Serial: NPD-NRC-2009-006

**SHEARON HARRIS NUCLEAR POWER PLANT, UNITS 2 AND 3
DOCKET NOS. 52-022 AND 52-023
RESPONSE TO REQUEST FOR ADDITIONAL INFORMATION LETTER NO. 020 RELATED TO
STABILITY OF SUBSURFACE MATERIALS AND FOUNDATIONS – SUPPLEMENT 2**

**Shearon Harris Nuclear Power Plant Units 2 and 3
Supplement 2 to Response to NRC Request for Additional Information Letter No. 020
Related to SRP Section 02.05.04 for the Combined License Application,
dated September 26, 2008**

FIGURE 2: Summary of Wedge Configurations and Input Parameters – Sliding Evaluations

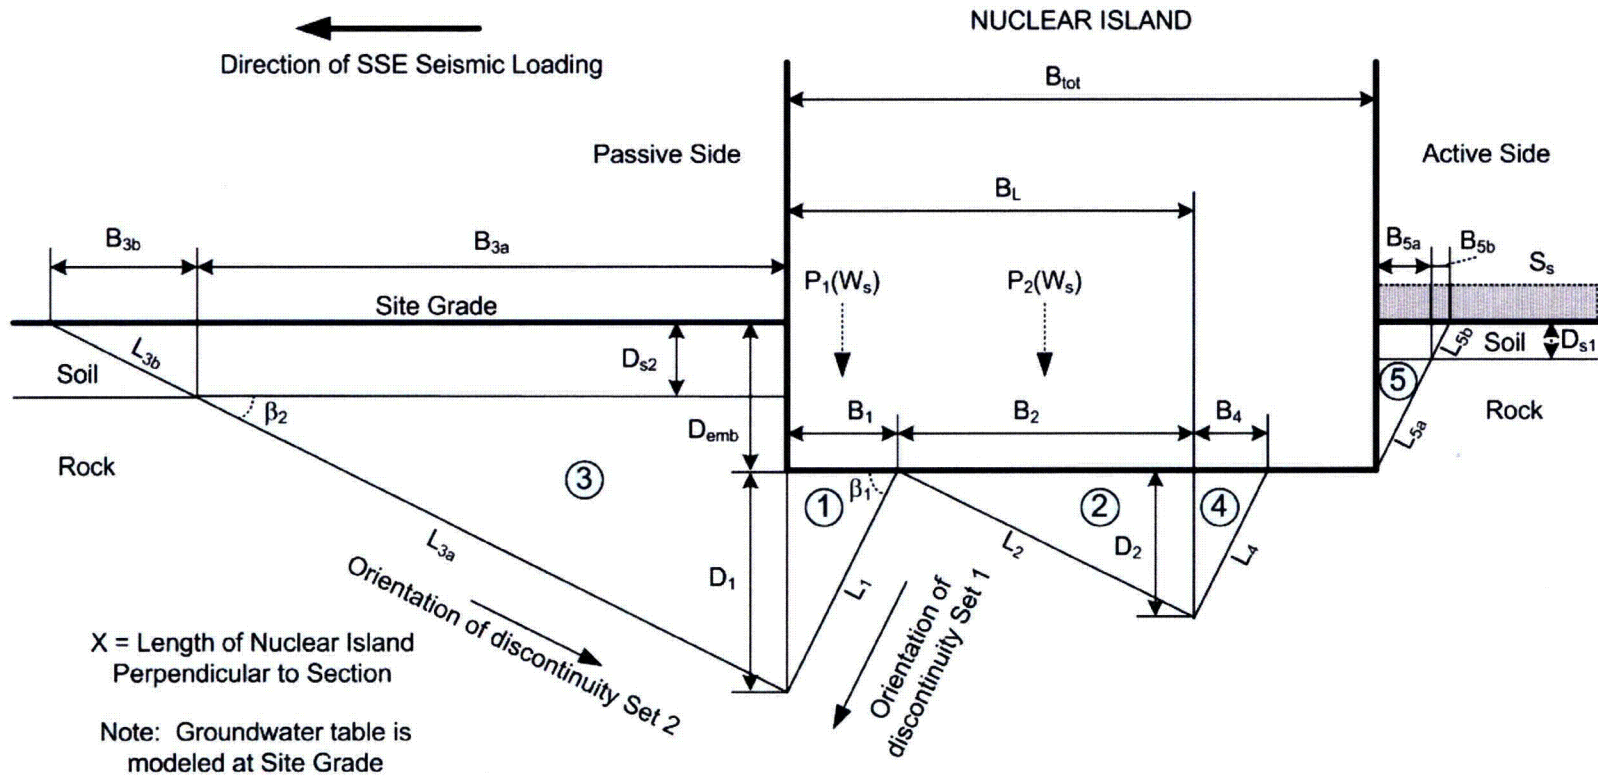
Please provide all the lateral earth pressures required by AP1000 DCD, Tier 2, and Section 2.5.4.6.7. Provide sample calculations showing the assumptions and methods used in the calculation of the dynamic active and passive lateral earth pressures.

The sliding stability evaluations were based on the force equilibrium of five wedges representing soil and rock below and on the active and passive sides of the nuclear island. Figure RAI 02.05.04-8-001 shows the configuration of the nuclear island and associated rock and soil wedges considered in the sliding stability evaluations. Conservative assumptions were applied to convert the three-dimensional nuclear island and subsurface configuration to an equivalent limited-width two-dimensional model. Two-dimensional profiles associated with each of the four orthogonal directions at HAR 2 and HAR 3 (total of eight profiles) were evaluated. The resulting FS against sliding in each direction were then compared to minimum required value (FS_s) of 1.1.

5. Add new Subsection 2.5.4 figure (referenced as "Figure RAI 02.05.04-8-001" herein).
6. Add new Subsection 2.5.4 table (referenced as "Table RAI 02.05.04-8-001" herein).
7. Add new COLA Part 10 Table 3.8-3.
8. Add new references as listed below to Subsection 2.5.7.
